# Access Compliance Report

## Public Rights-of-Way

### (Curb Ramps)

Intersection ID: N/A	Main Street: E_3RD_ST	Cross Street: S_MCDOWELL_ST	Location: N
ADA ID: 0E6419162EE7	Ramp Type: Perp	Initial Pass/Fail: Fail	Overall Compliance: No
			Severity Score: 13.75

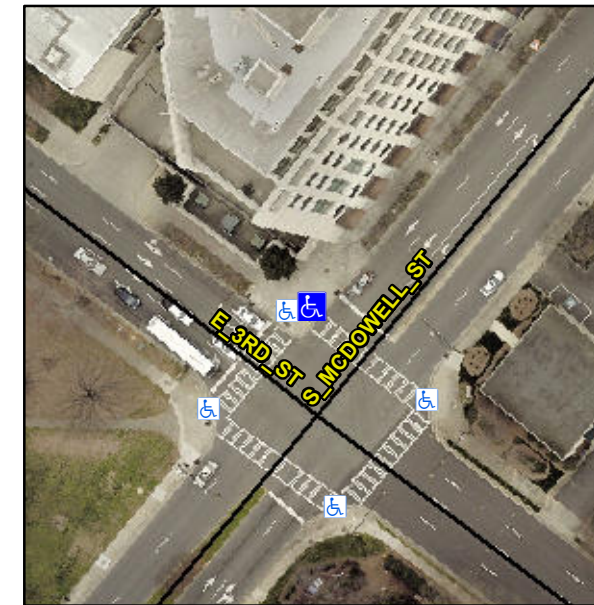
**Not Found, R304.2.2, R304.5.3**

**Remove & Replace Entire Ramp.**
